City of Richmond

Report to Development Permit Panel

To: Development Permit Panel **Date:** February 17, 2015
From: Wayne Craig **File:** DP 13-644888
Director of Development
Re: Application by Balandra Development Inc. for a Development Permit at 8600 and
8620 No. 2 Road

Client/Title
Landscape Plan

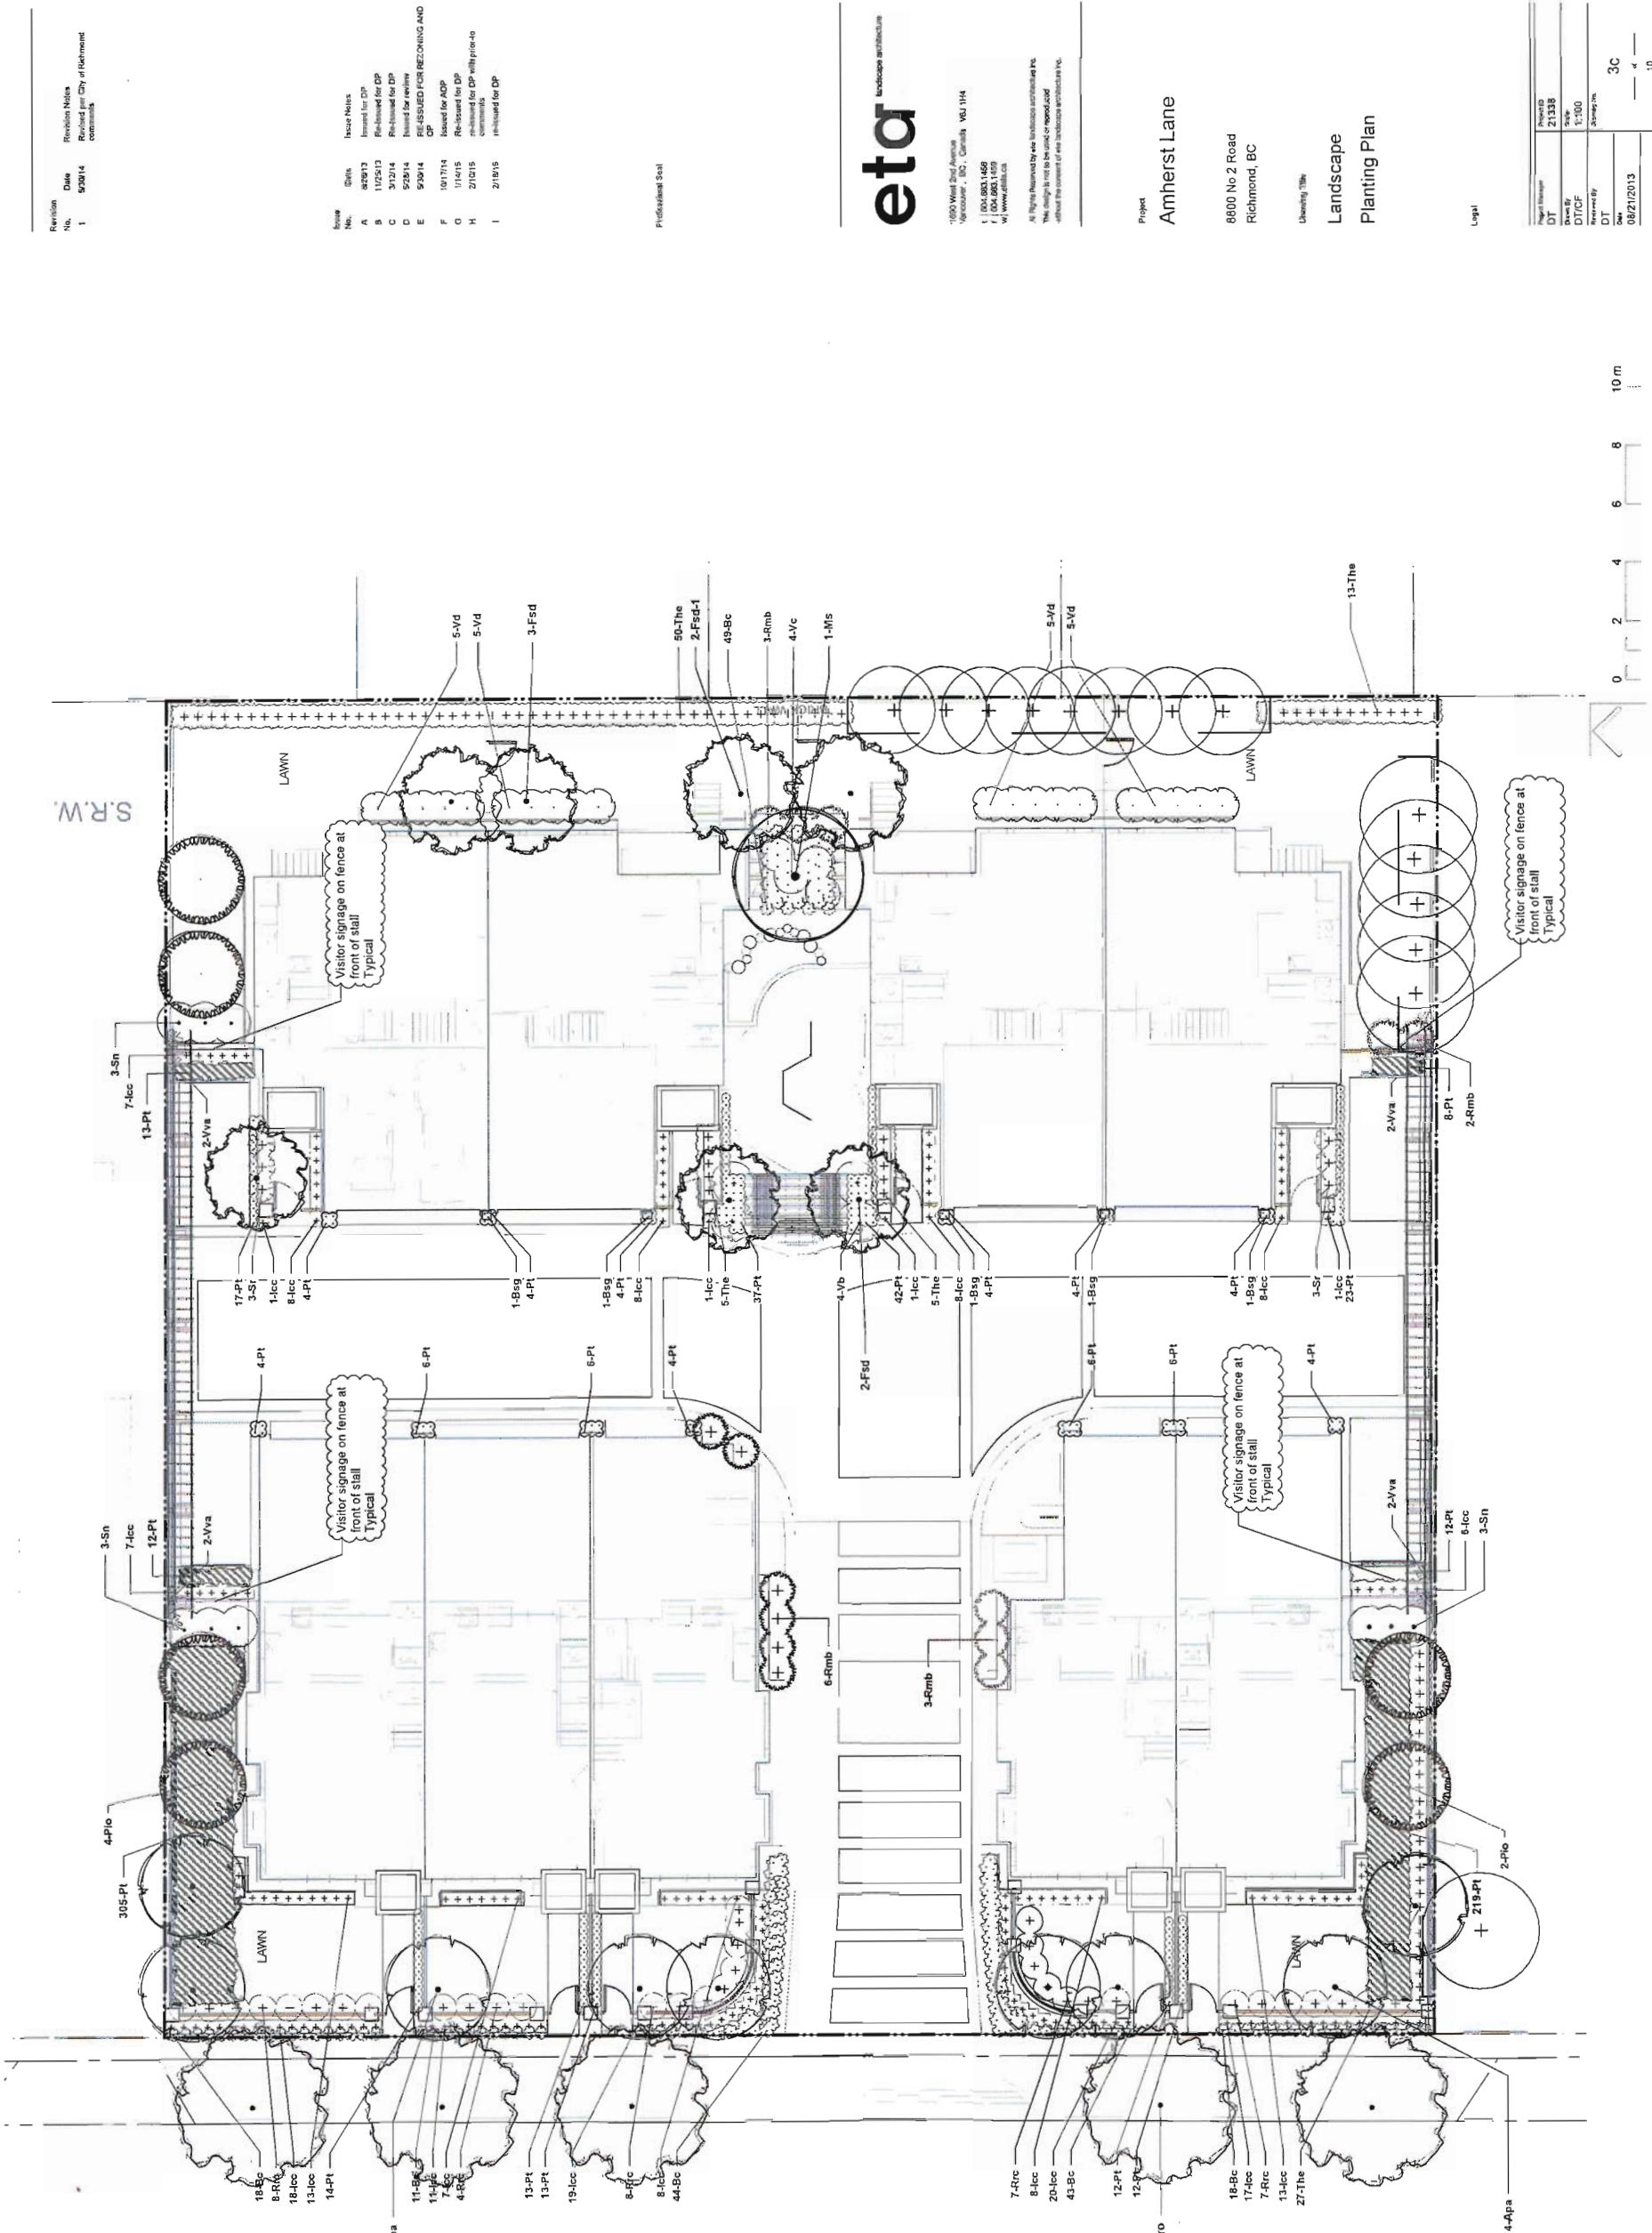
- side elevations are not symmetrical; look at the rooflines;
No Comment.
- consider increasing the area of the outdoor amenity to make it more visually significant;
We have reviewed on increasing in the bulge of the road intersection. There was no significant increasing in the landscaping and the curb pattern was less pleasing in central open space. Final solution is shown on plan# L3b.

UNIT 9D3
FLOOR PLANS
(CONVERTIBLE UNIT)

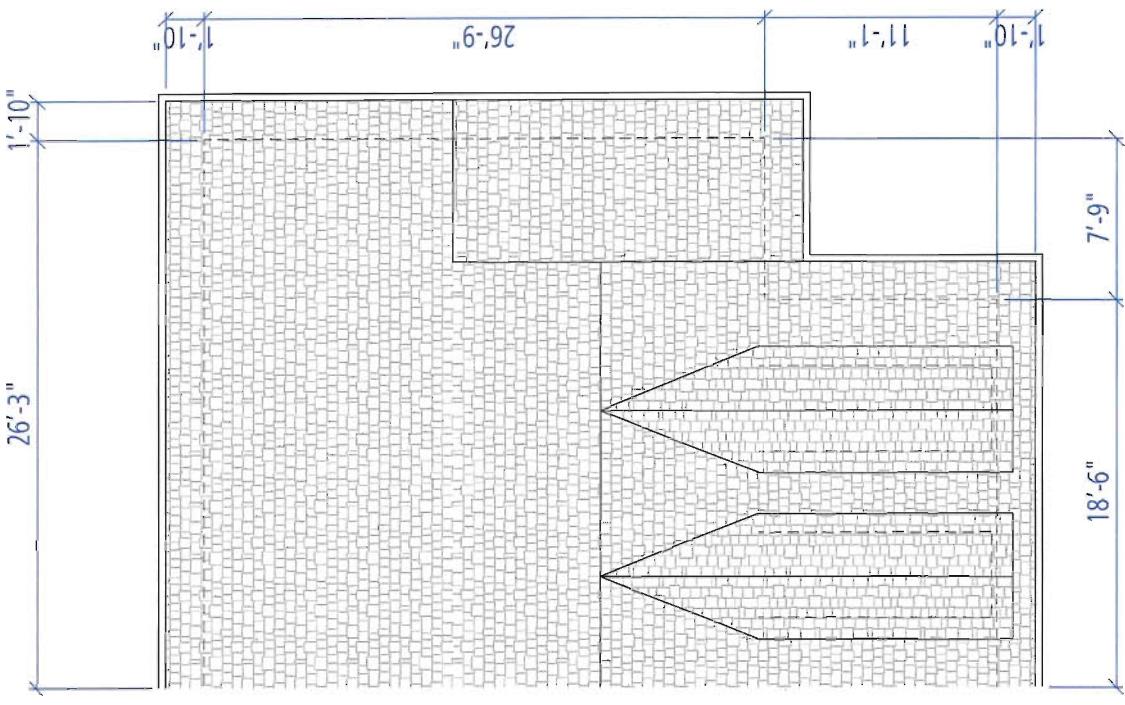
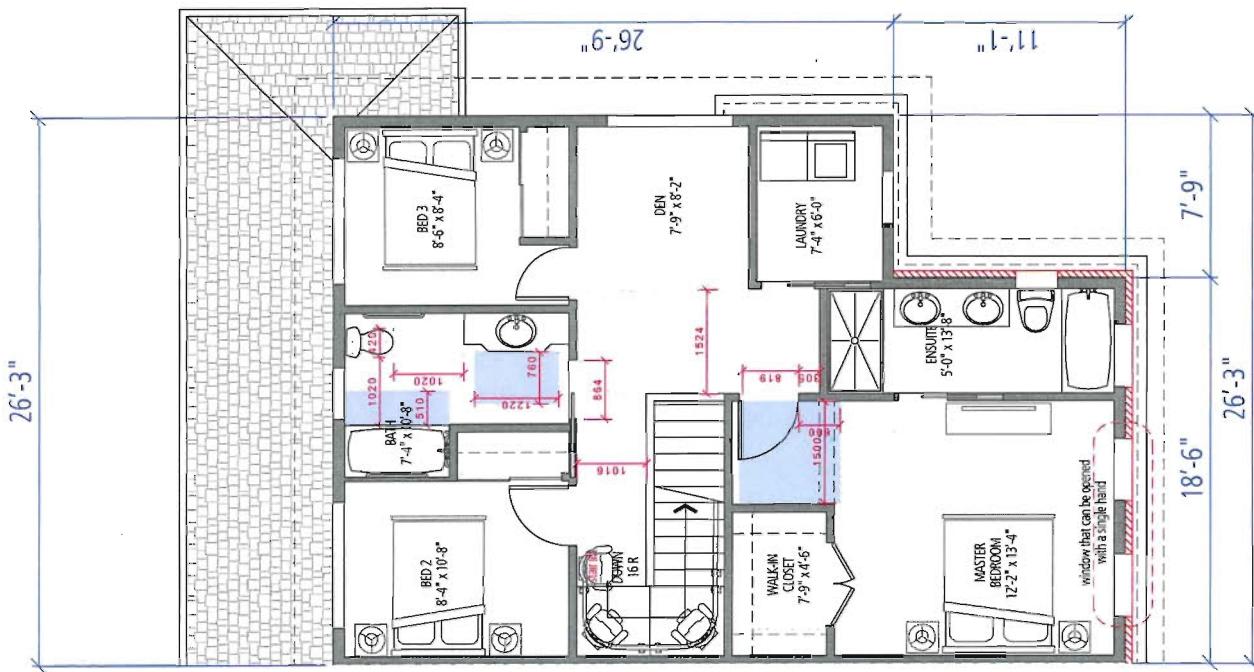
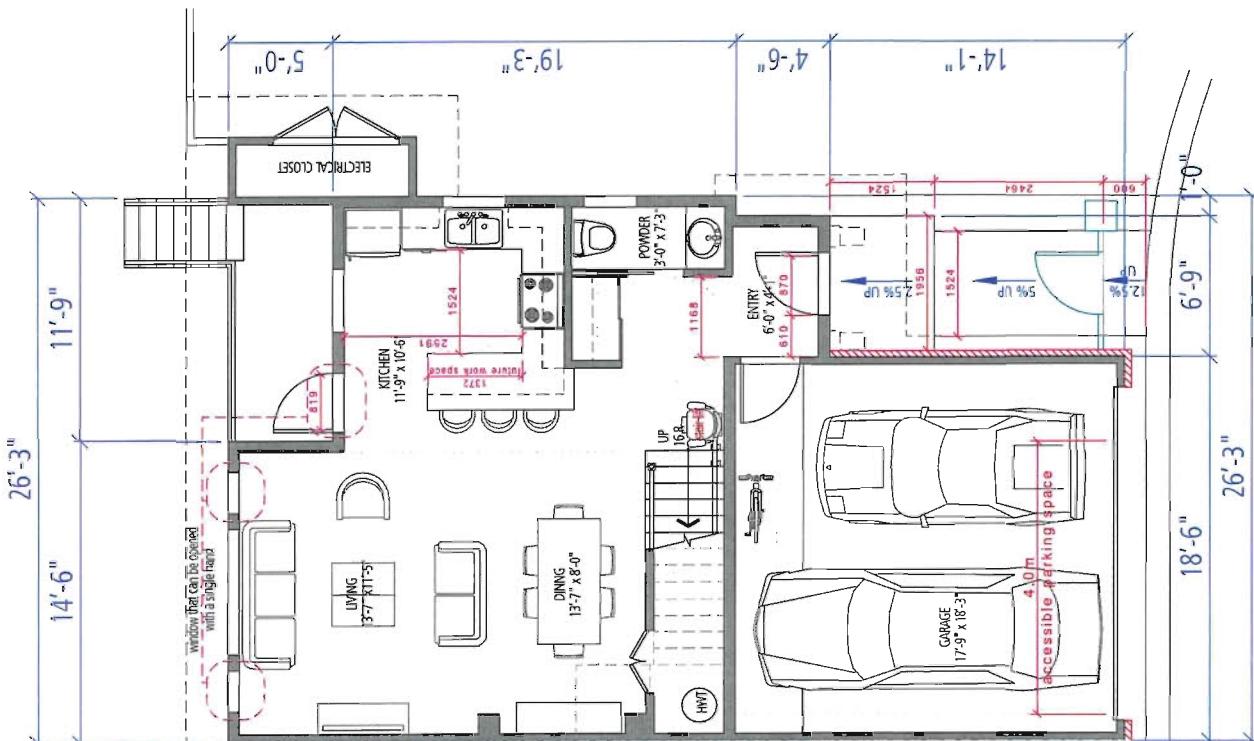
- appreciate the provision of a convertible unit and use of sliding doors in the powder room on the ground floor and in the bathroom on the upper floor; consider pocket doors for the ensuite bathroom and laundry room on the upper floor in lieu of swinging doors to free up floor space and improve accessibility; also consider the same approach to the other units in the proposed development;
Please see attached plan#07.
